2.0

PROPOSED SCHEME CHANGES

2.4 SECOND FLOOR PLAN

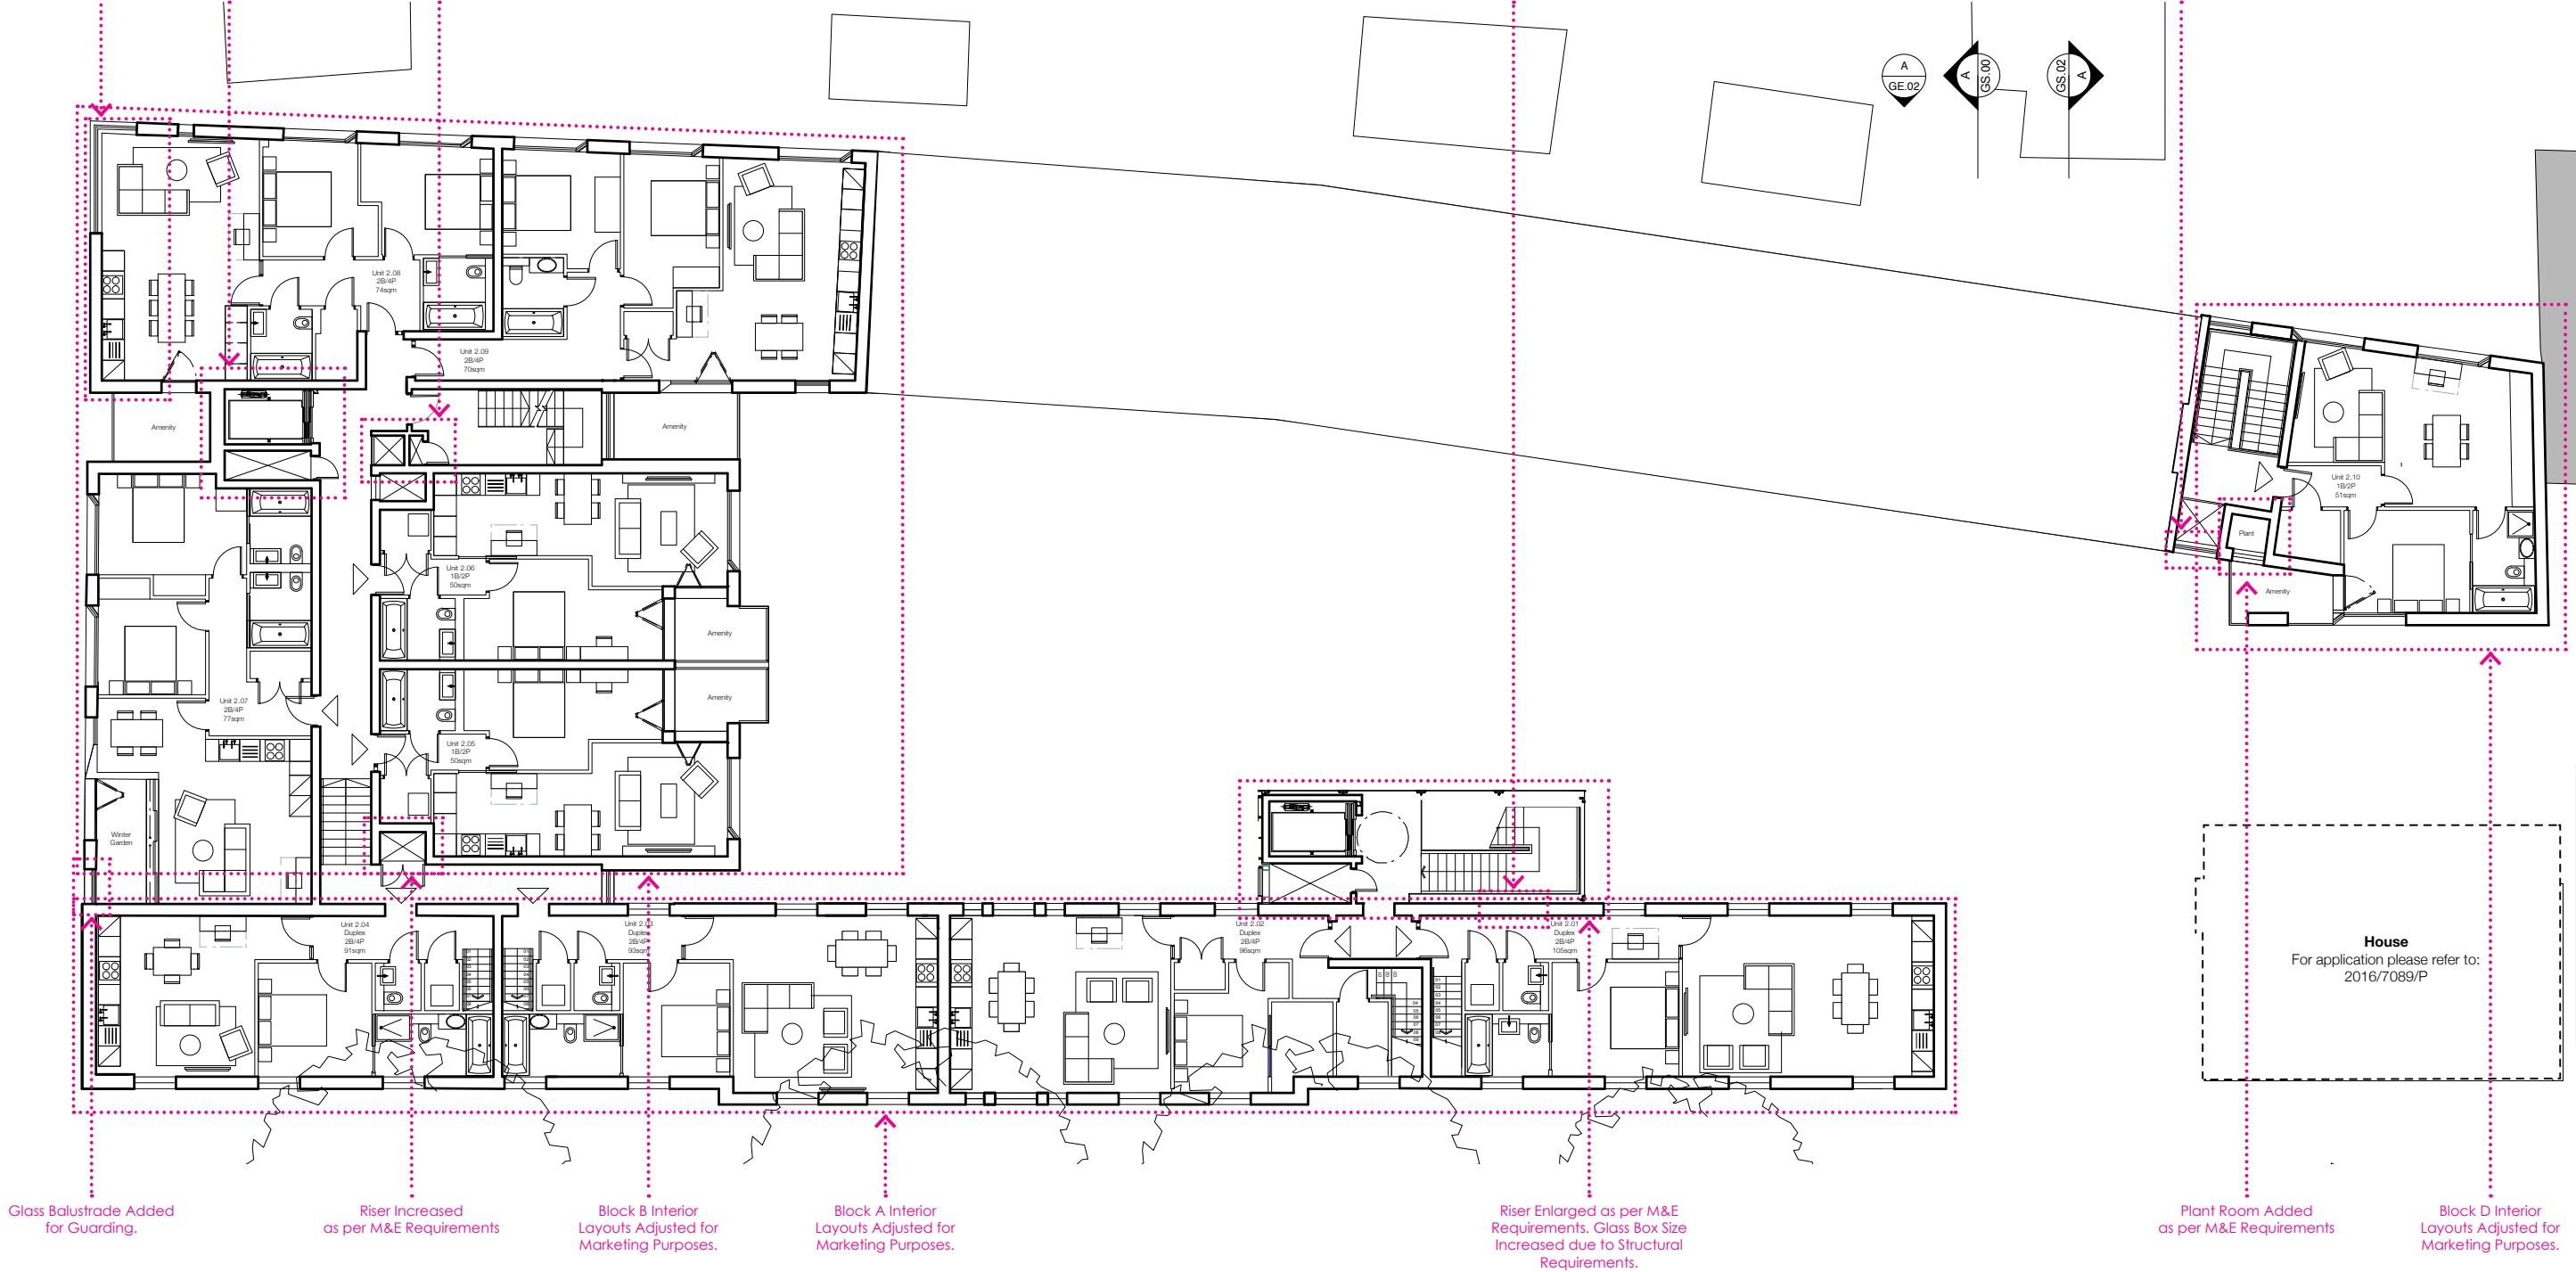
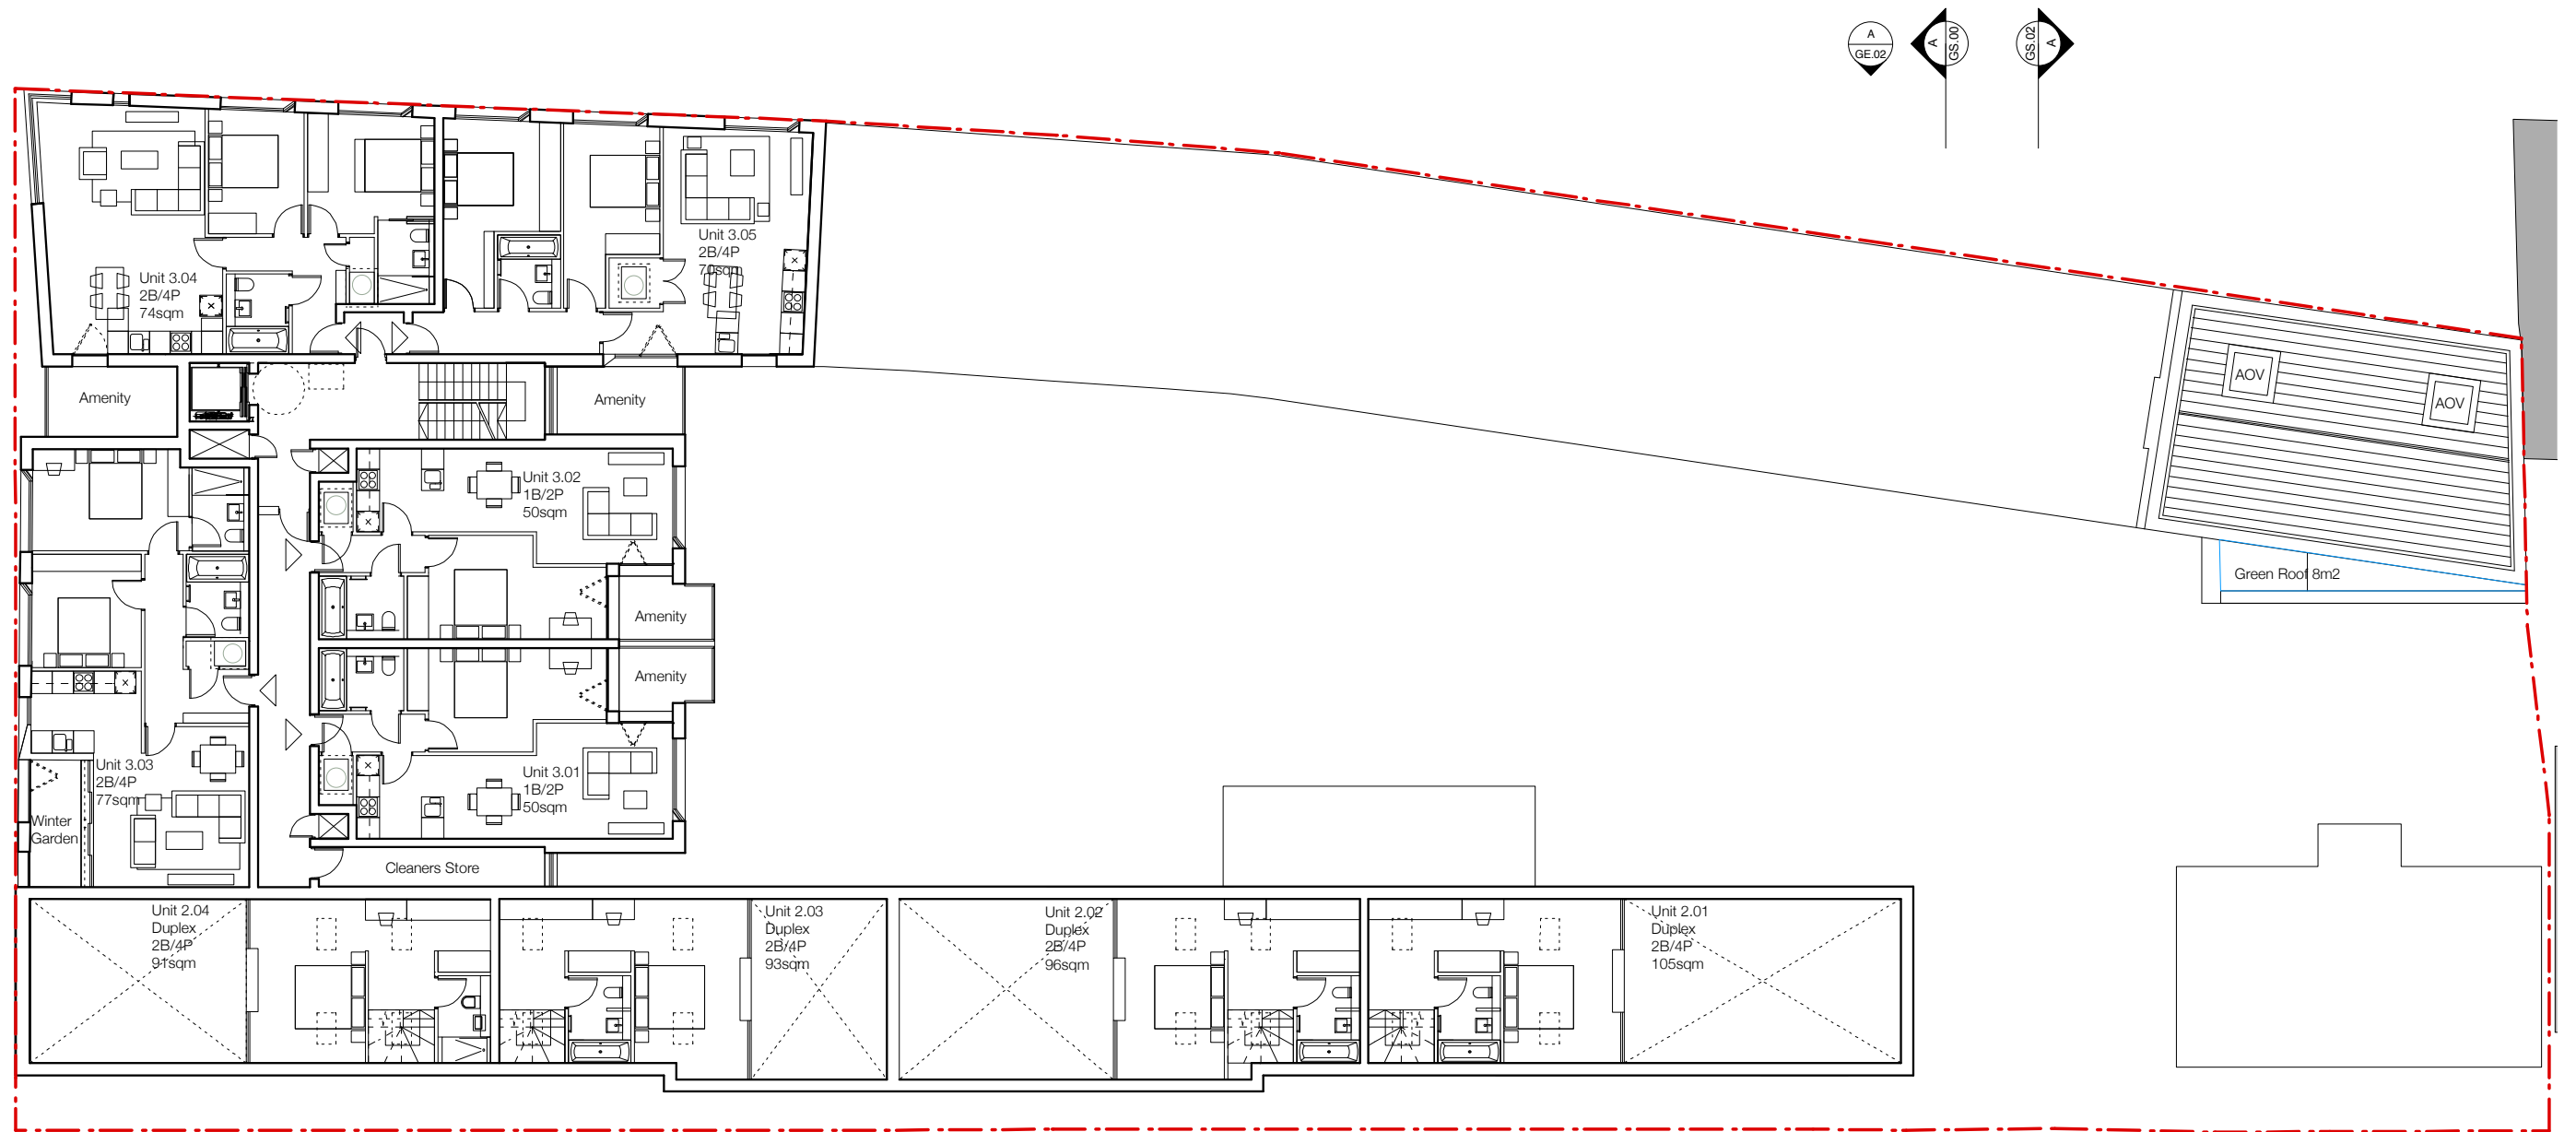
Building Facade Angle
Adjusted for Buildability whilst
Retaining the Architectural
Language.

Risers Enlarged as per Plant
Requirements

Risers Added as per
Plant Requirements

Window Infilled to
Achieve Fire Rating

Window Added to Drawing
(Previous Issue Drawing Error)

Glass Balustrade Added
for Guarding.

Riser Increased
as per M&E Requirements

Block B Interior
Layouts Adjusted for
Marketing Purposes.

Block A Interior
Layouts Adjusted for
Marketing Purposes.

Riser Enlarged as per M&E
Requirements. Glass Box Size
Increased due to Structural
Requirements.

Plant Room Added
as per M&E Requirements

Block D Interior
Layouts Adjusted for
Marketing Purposes.
